November 8, 2005
LIC-05-0119

**SUBJECT: Fort Calhoun Station Unit No. 1 License Amendment Request (LAR) 05-013,
"Criticality Control During Spent Fuel Cask Loading in the Spent Fuel Pool"**

Omaha Public Power District's Evaluation
for
Amendment of Operating License

“Criticality Control During Spent Fuel Cask Loading in the Spent Fuel Pool”

Figure 2-11

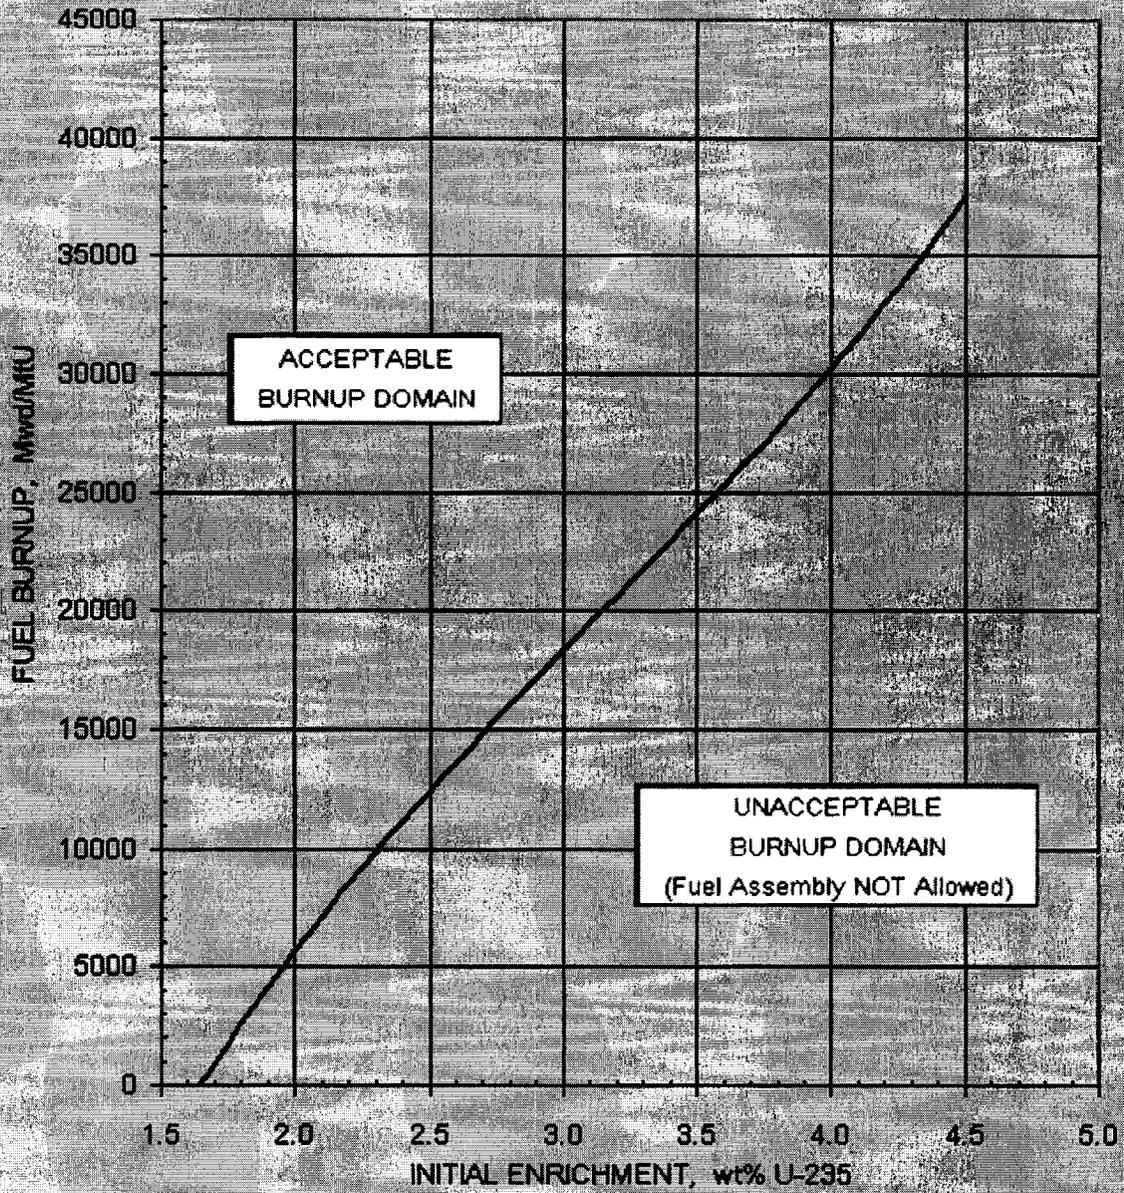
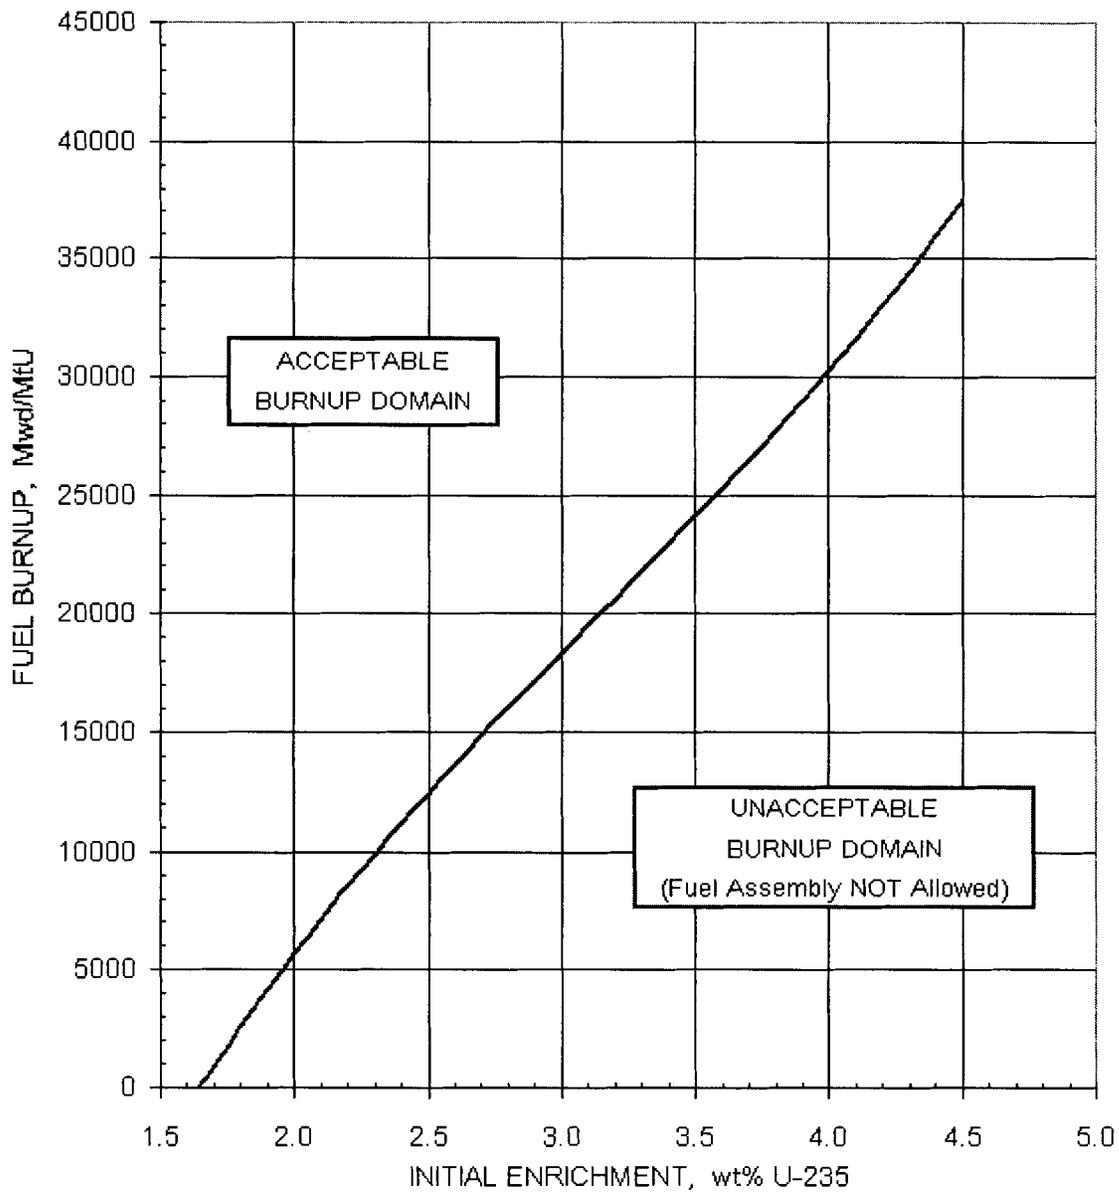
This new LCO adds: 1) a new minimum boron concentration limit (800 ppm) for the spent fuel pool during spent fuel cask loading operations and 2) a new burnup versus enrichment curve for fuel assemblies located in a spent fuel cask in the spent fuel pool. New bases for new LCO 2.8.3(6) have been created and are included for information.

- (1) The spent fuel pool boron concentration shall be ≥ 800 ppm, and
- (2) The combination of initial enrichment and burnup of each spent fuel assembly located in a spent fuel storage cask in the spent fuel pool shall be within the acceptable burnup domain of Figure 2-11.

- (1) With the spent fuel pool boron concentration < 800 ppm, suspend REFUELING OPERATIONS involving spent fuel cask loading immediately, and
- (2) Restore spent fuel pool boron concentration to ≥ 800 ppm immediately.
- (3) With the requirements of the LCO 2.8.3(6)(2) not met, initiate action to remove the noncomplying fuel assembly from the spent fuel cask immediately.
